RE: Meadow Lane Retaining Wall Replacement

**Subject: Fieldstone Farms (aka Meadow Lane)
Retaining Wall Replacement Plan Review**

- Plans entitled Retaining Wall Replacement Located at Meadow Lane, Grafton, MA dated April 10, 2017 and last revised July 24, 2017, prepared by Land Planning, Inc. for Magill Associates, Inc. (2 sheets)

Culvert Through Wall Section

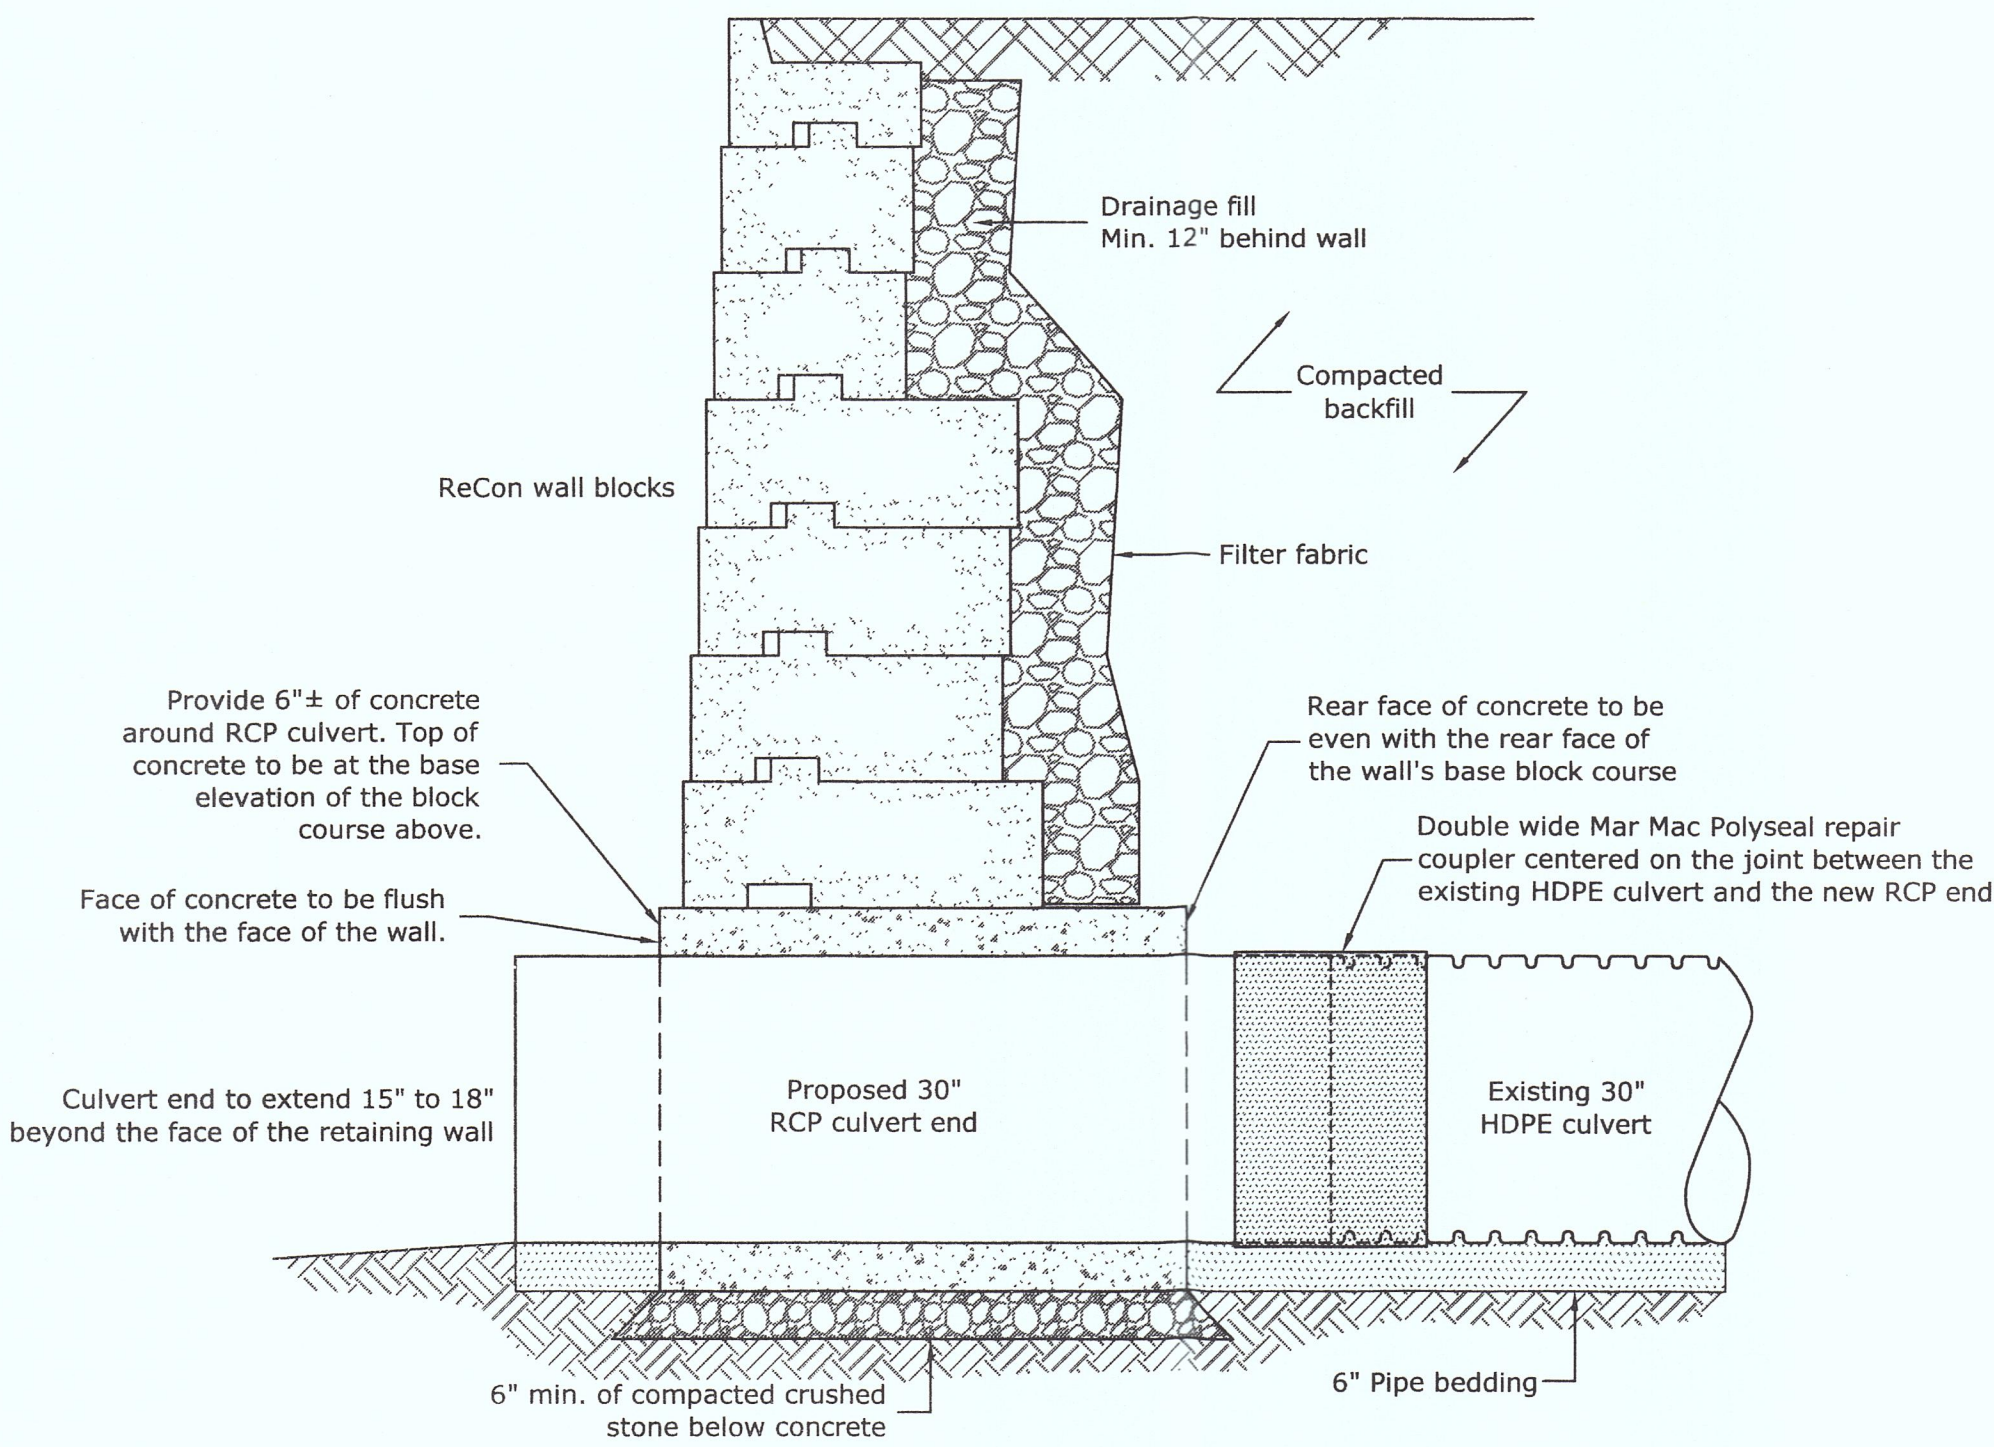
This design calls for a 6" cocoon of concrete to be placed around the reinforced concrete pipe. The cocoon is being used as a pad between the ReCon blocks and the pipe. I suggest the use of #4 reinforcing rods (Each-Way @ 6" oc on all three sides of the cocoon), as reinforcement in this concrete cocoon. This suggestion is based on the fact that the existing pipe has been crushed so I believe that this additional reinforcement makes good sense. This change only requires a note on the present plans.

1. *The "Culvert Through Wall Section" on Sheet 2 of the plans proposes only six inches of concrete around the culvert pipe and mislabeled the culvert pipe as "RCP" instead of "HDPE." We are concerned about the load being placed onto the HDPE culvert. A reinforced concrete lintel of sufficient strength needs to be designed to span each of the three culvert penetrations, and the mislabeling of the pipe material needs to be corrected.*

The design engineer responded that reinforced concrete pipe is to replace the high-density polyethylene pipe at the walls. This approach is reasonable. However, the "Culvert Through Wall Section" construction detail proposes that the two pipe materials are to be butted together with only a "doublewide Mar Mac polyseal repair coupler" to seal (cover) the joint between the two pipe materials. Due to the different pipe materials (rigid concrete and flexible HDPE), one pipe could be displaced from the other due to shear forces. Our research found that in addition to the Mar Mac seal, the pipes need to be protected from movement by using an HDPE "internal coupler spigot adapter" (not recommended for use when the HDPE pipe is downstream from the RCP), a similar bell/spigot-type connection, a coupling connection, or a concrete collar.

1. The "Culvert Through Wall Section" on Sheet 2 of the plans proposes only six inches of concrete around the culvert pipe and mislabeled the culvert pipe as "RCP" instead of "HDPE." We are concerned about the load being placed onto the HDPE culvert. A reinforced concrete lintel of sufficient strength needs to be designed to span each of the three culvert penetrations, and the mislabeling of the pipe material needs to be corrected.

The design engineer responded that reinforced concrete pipe is to replace the high-density polyethylene pipe at the walls. This approach is reasonable. However, the "Culvert Through Wall Section" construction detail proposes that the two pipe materials are to be butted together with only a "doublewide Mar Mac polyseal repair coupler" to seal (cover) the joint between the two pipe materials. Due to the different pipe materials (rigid concrete and flexible HDPE), one pipe could be displaced from the other due to shear forces. Our research found that in addition to the Mar Mac seal, the pipes need to be protected from movement by using an HDPE "internal coupler spigot adapter" (not recommended for use when the HDPE pipe is downstream from the RCP), a similar bell/spigot-type connection, a coupling connection, or a concrete collar.

2. *The "Culvert Through Wall Section" on Sheet 2 of the plans proposes only six inches of concrete around the culvert pipe and mislabeled the culvert pipe as "RCP" instead of "HDPE." We are concerned about the load being placed onto the HDPE culvert. A reinforced concrete lintel of sufficient strength needs to be designed to span each of the three culvert penetrations, and the mislabeling of the pipe material needs to be corrected. The design engineer responded that reinforced concrete pipe is to replace the high-density polyethylene pipe at the walls. This approach is reasonable. However, the "Culvert Through Wall Section" construction detail proposes that the two pipe materials are to be butted together with only a "doublewide Mar Mac polyseal repair coupler" to seal (cover) the joint between the two pipe materials. Due to the*

different pipe materials (rigid concrete and flexible HDPE), one pipe could be displaced from the other due to shear forces. Our research found that in addition to the Mar Mac seal, the pipes need to be protected from movement by using an HDPE "internal coupler spigot adapter" (not recommended for use when the HDPE pipe is downstream from the RCP), a similar bell/spigot-type connection, a coupling connection, or a concrete collar.

2. The "Culvert Through Wall Section" on Sheet 2 of the plans proposes only six inches of concrete around the culvert pipe and mislabeled the culvert pipe as "RCP" instead of "HDPE." We are concerned about the load being placed onto the HDPE culvert. A reinforced concrete lintel of sufficient strength needs to be designed to span each of the three culvert penetrations, and the mislabeling of the pipe material needs to be corrected.

Acknowledged. The "Culvert Through Wall Section" construction detail was revised to specify a "Fernco Large Diameter Series coupling" at the two pipe joints.

Acknowledged. The "Culvert Through Wall Section" construction detail was revised to specify a "Fernco Large Diameter Series coupling" at the two pipe joints.
